**FLOODWAY DEVELOPMENT PERMIT #851-22-000405-PLNG: CARLTON/HAT GIRL LLC**

**ADMINISTRATIVE DECISION & STAFF REPORT**

**Decision: APPROVED WITH CONDITIONS  
(This is not Building or Placement Permit Approval)**

Appendix B  
Photographic Log  
Site Reconnaissance  
June 22, 2022

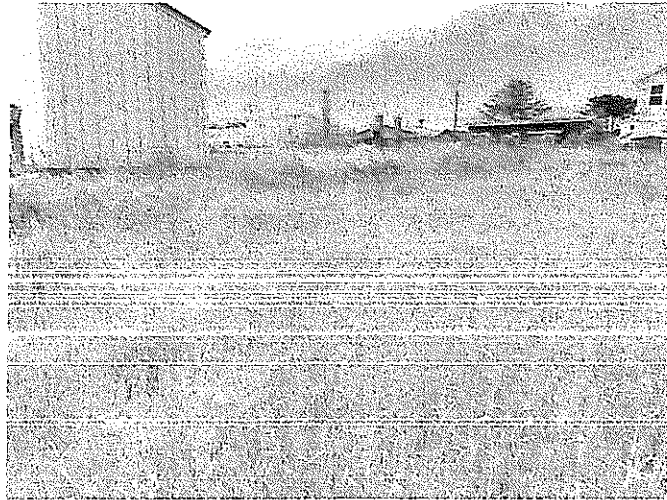
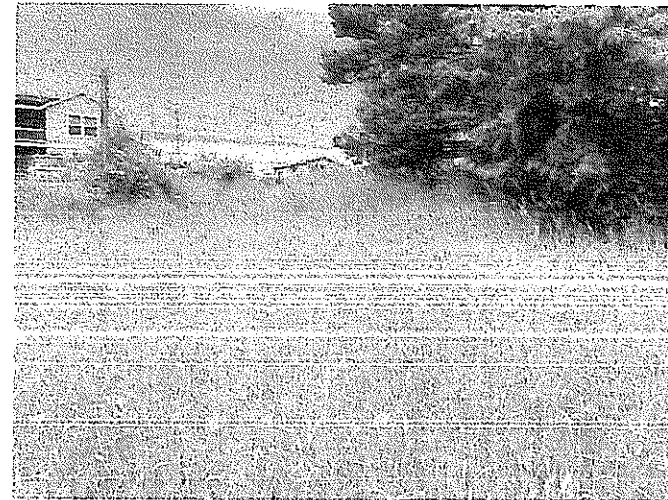
Although the wetlands inventory does not show wetlands in this vicinity, based on the aerial photo and included photos in the application, ODFW recommends the applicant contact the Department of State Lands for confirmation that the site does not contain wetlands prior to placing fill. If it is determined there are wetlands on site, the applicant will need to work with DSL on appropriate permitting.
